ADDENDUM #04

Project Name: Central County Fire & Rescue House #06

Project Number: 24057

Date: July 20, 2026

Sheet No.
C9.0

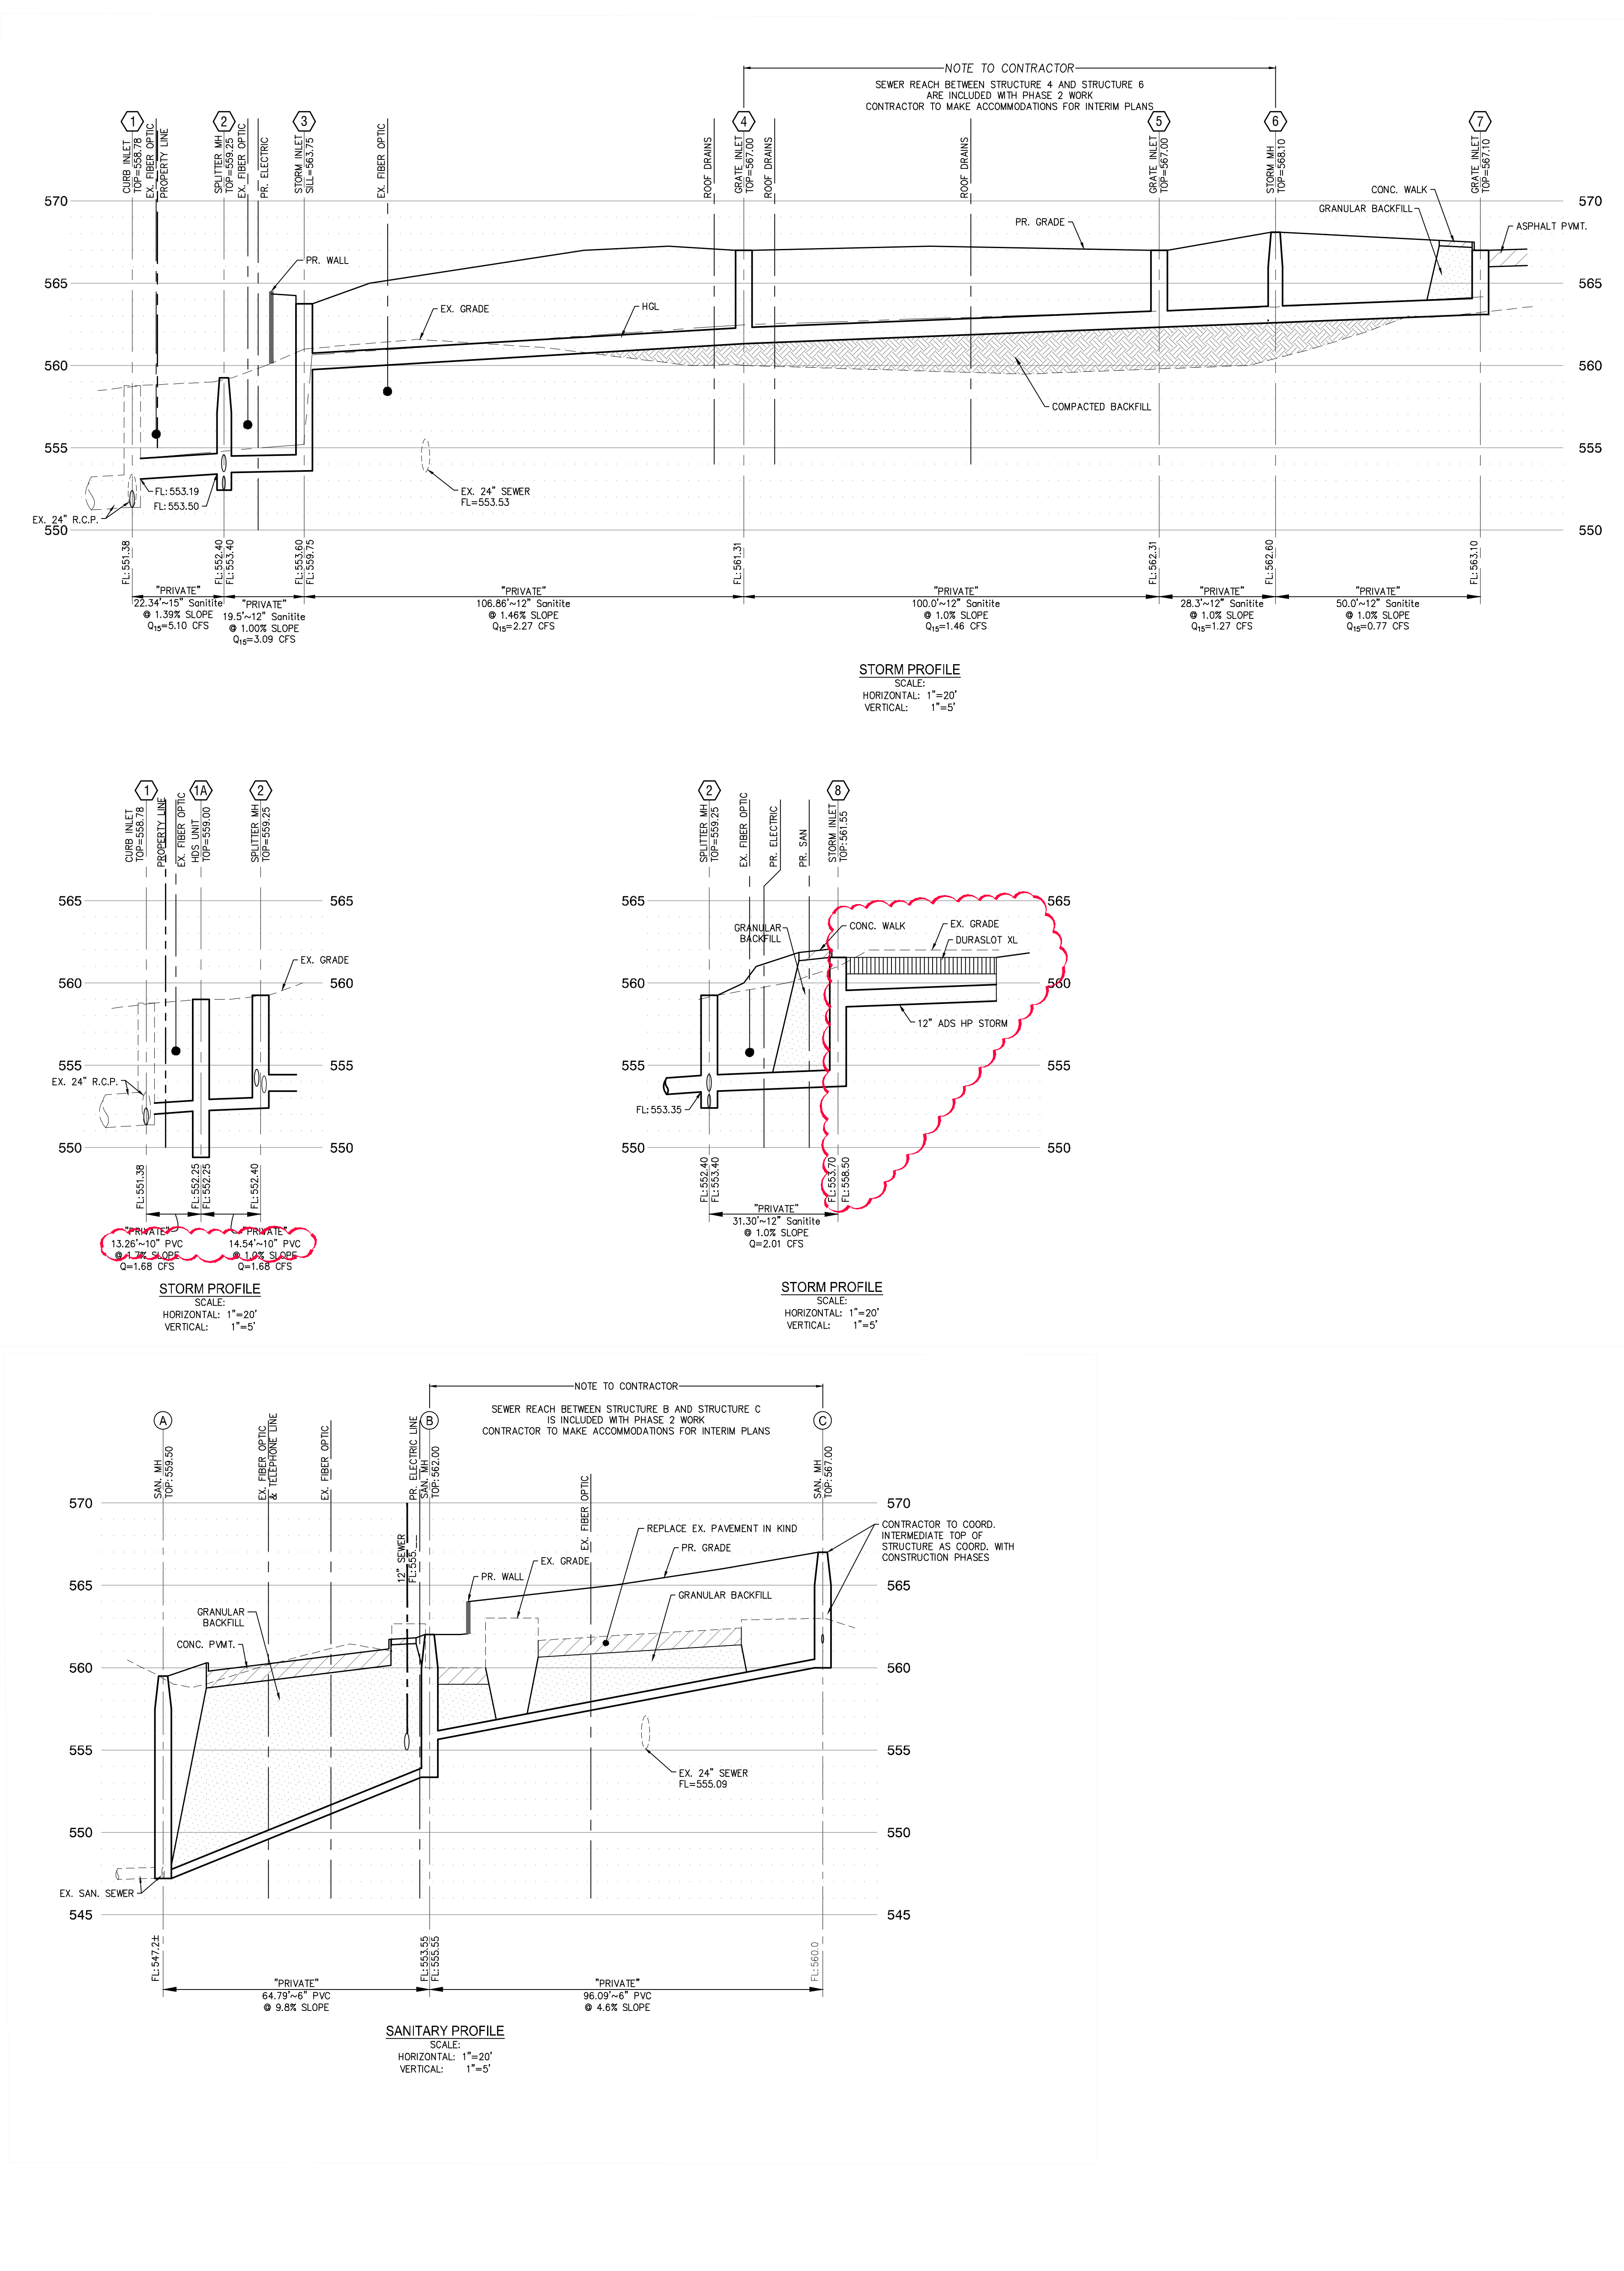
1. Sheet C5.0 – PHASE 1 - SITE GEOMETRY AND UTILITY PLAN
 - a. **Water service for relocated service to school noted as 6 inch**
2. Sheet C9 - PHASE 3 - EXISTING CONDITIONS & FACILITIES REMOVAL PLAN
 - a. **Revised demo limits as coordinate with current City plans**
 - b. **Contractor will need to work with City and their contractor once schedules and timelines are known**
3. Sheet C12 - SEWER PROFILES AND HYDRAULIC CALCULATIONS
 - a. **10" PVC for inlet and outlet to HDS**
 - b. **Slot drain noted**
4. Sheet C13 - SEWER DETAILS
 - a. **Duraslot XL detail added and Neenah trench removed**
5. Sheet C15.1 - BEST MANAGEMENT PRACTICES PLAN
 - a. **ARCADIA revised to AR5**
6. Sheet C11.1 - CITY SCOPE EXHIBIT
 - a. **Exhibit added to help clarify City project along Jungs Station**

A1 LIFE SAFETY PLAN
1/8" = 1'-0"

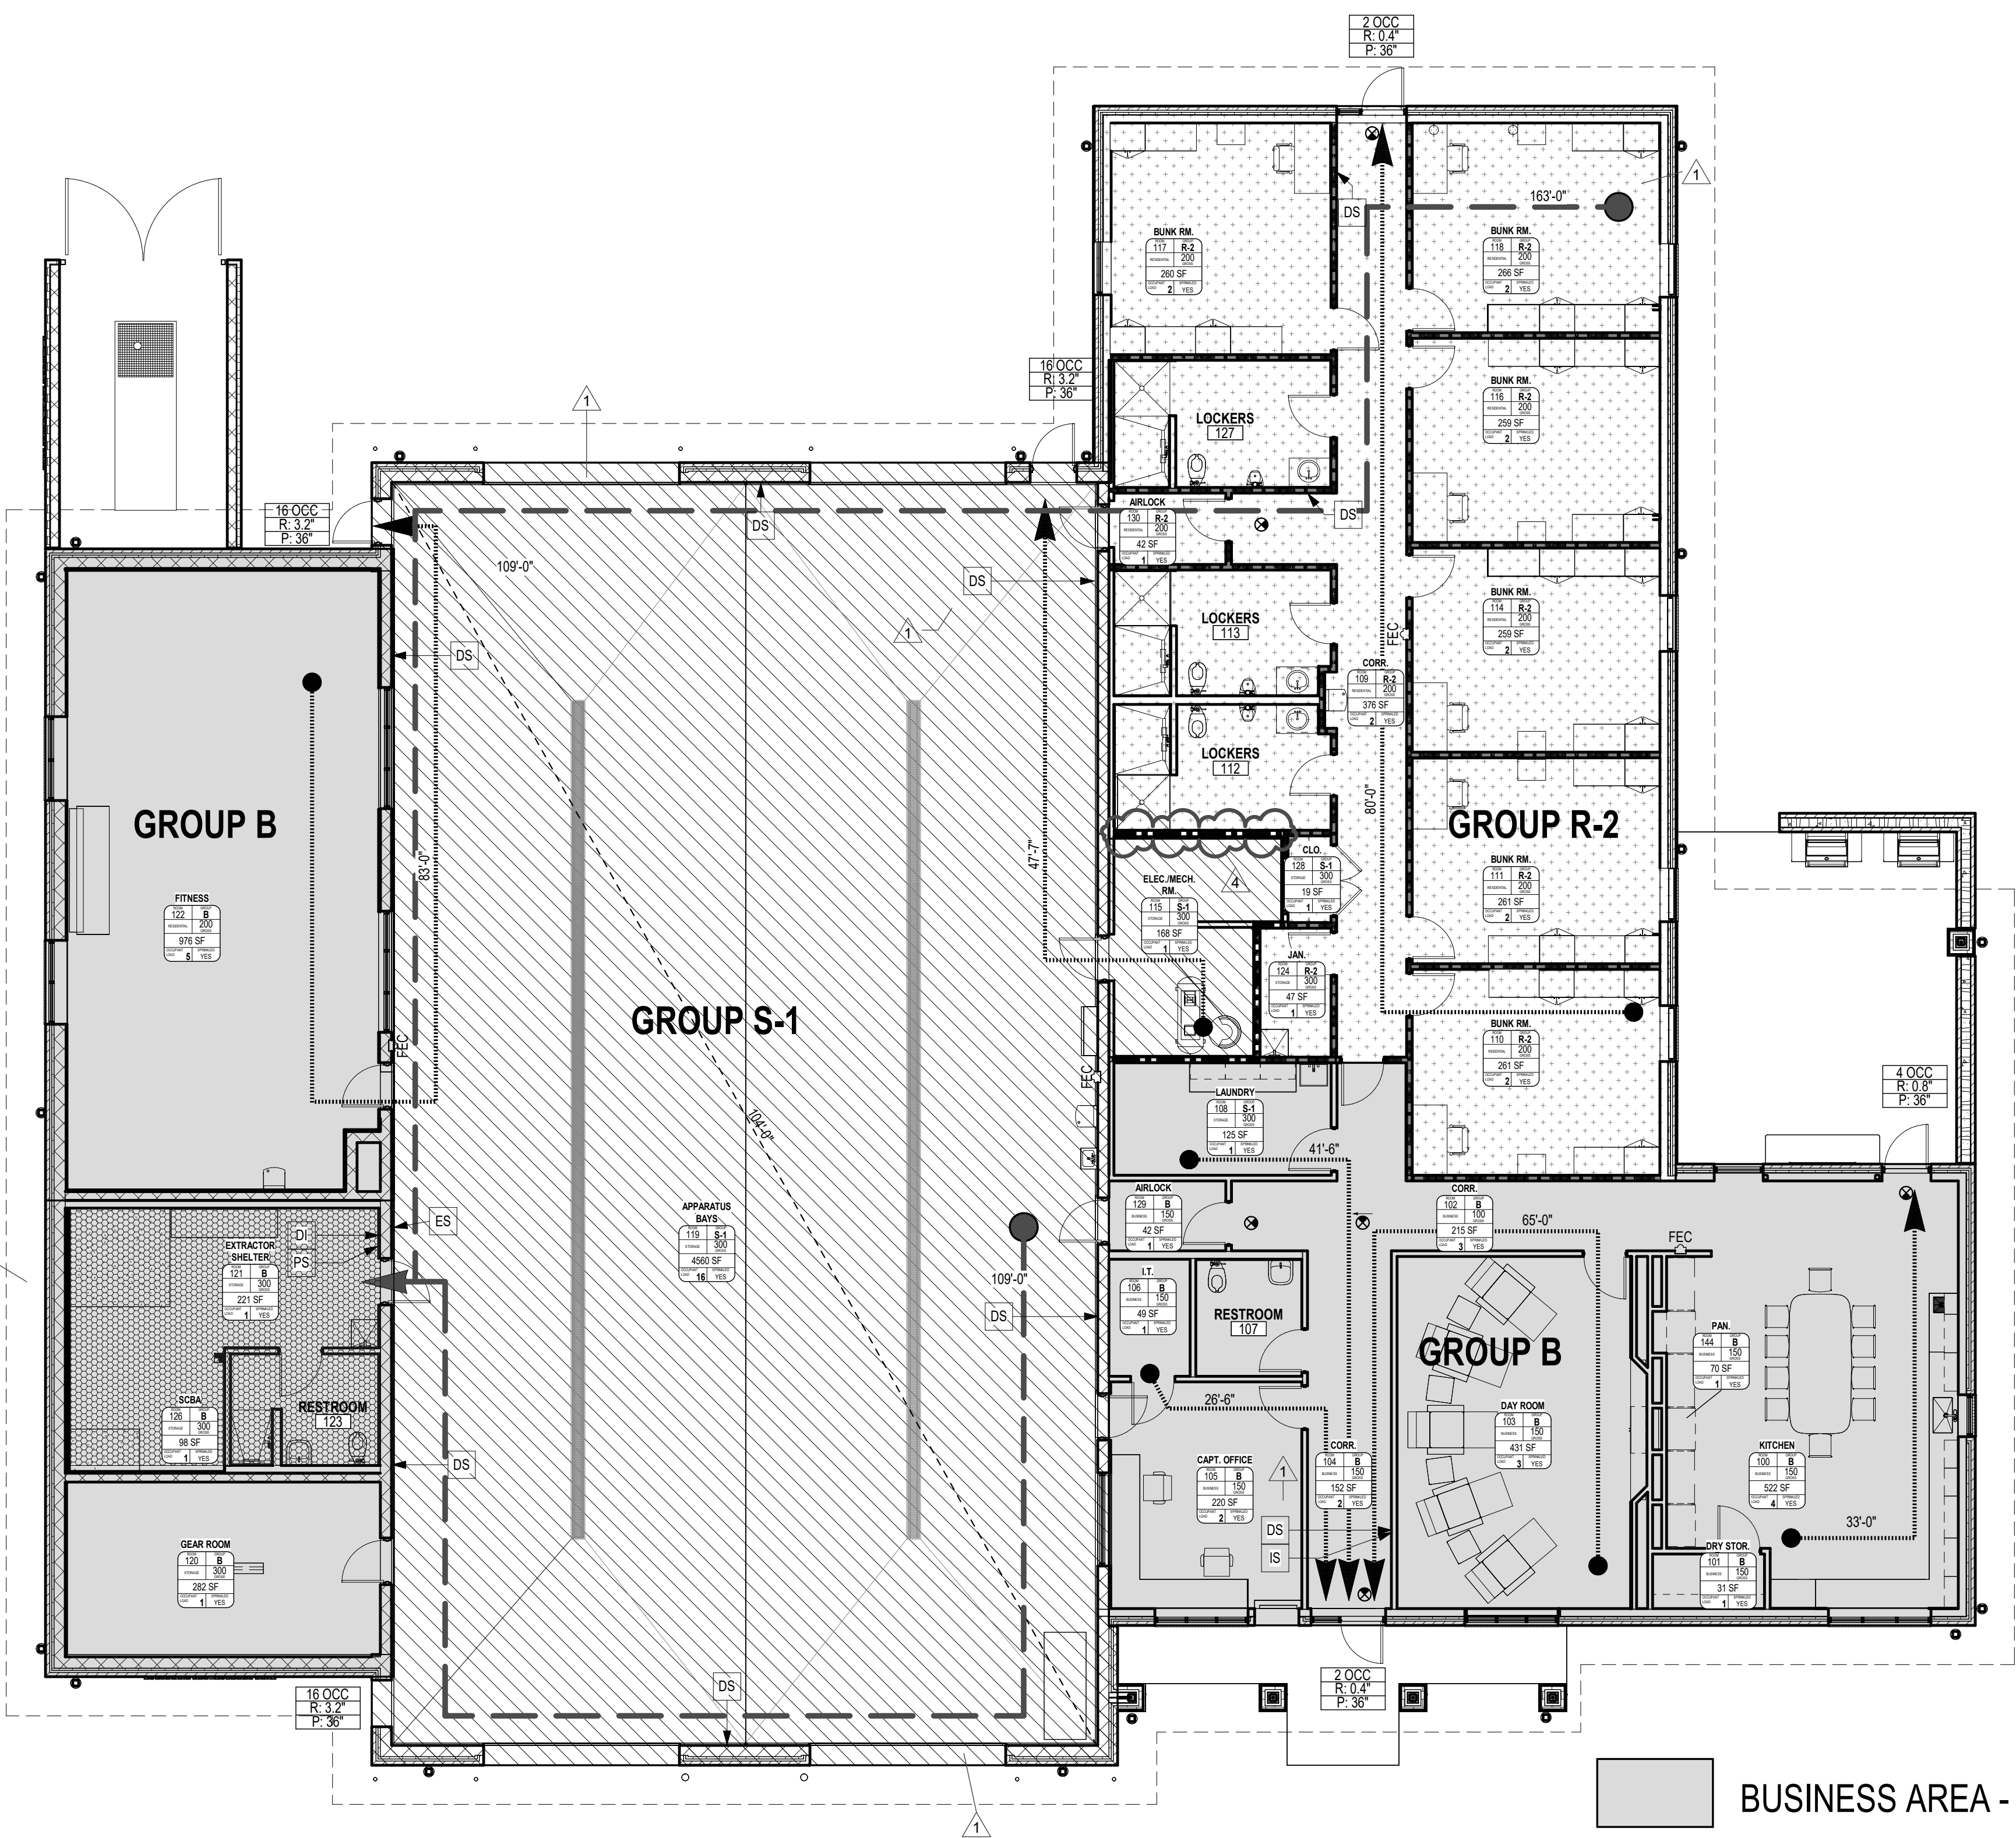
1. Sheet A004: Life Safety Plan
 - a. **Rated wall hatch was updated.**
 - b. **Reference attached Revised Sheet.**
2. Sheet A111: Floor Plan
 - a. **Rated wall hatch was updated.**
 - b. **Reference attached Revised Sheet.**
3. Sheet A112: Dimension Floor Plan
 - a. **Rated wall hatch was updated.**
 - b. **Reference attached Revised Sheet.**
4. Sheet A415: Enlarged Floor Plans
 - a. **Rated wall hatch was updated.**
 - b. **Reference attached Revised Sheet.**
5. Sheet A701: Equipment & Furniture Plan
 - a. **Equipment schedule modified**
 - b. **Reference attached Revised Sheet.**
